DOMINION NUCLEAR CONNECTICUT, INC.
MILLSTONE POWER STATION UNIT 3
RESPONSE TO REQUEST FOR ADDITIONAL INFORMATION REGARDING RELAXATION REQUEST IR-2-46, REACTOR PRESSURE VESSEL HEAD INSPECTIONS, (TAC NO. MD1735)

RELAXATION REQUEST IR-2-46, REACTOR PRESSURE VESSEL HEAD INSPECTIONS (TAC NO. MD1735)

RESPONSE TO REQUEST FOR ADDITIONAL INFORMATION

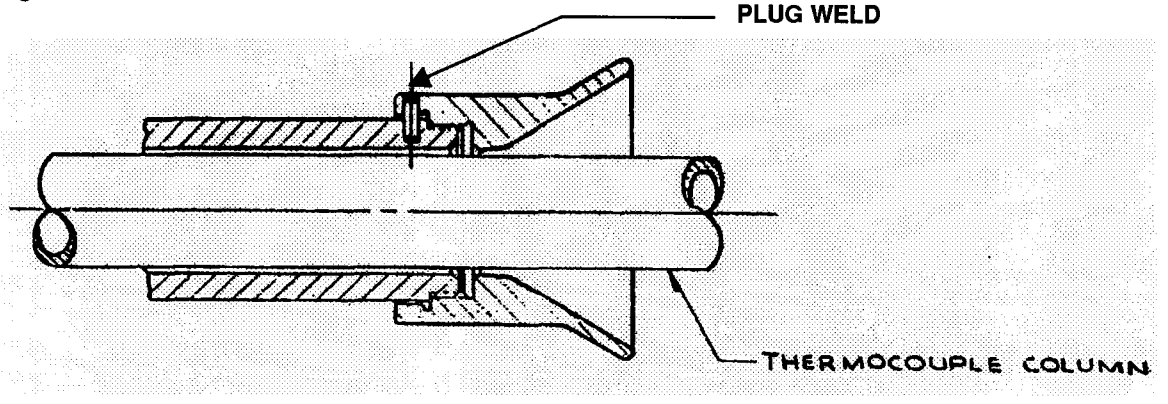
NRC Question No. 1

Provide details of the attachment of the guide funnel to the nozzle, including details of the weld length, size, filler material type, etc.

NRC Question No. 3

When determining the operating stresses in the nozzle at the top of the guide funnel, how will the weld attaching the guide funnel to the nozzle be taken into consideration?

The guide funnel to the nozzle is essentially a threaded attachment, as is shown in the figure below.

Detailed drawings that are being used to plan for this inspection provide a detail that shows a plug-welded pin through the guide funnel. The assembly drawing shows the pin and threading that are used to attach the guide funnel to the nozzle. Therefore, DNC concludes that the nozzle material was not welded to attach the guide funnels.

The operating stresses in the nozzle are not affected by the use of a plug weld on the guide funnel. Refer to the figure in response to NRC Question 1.
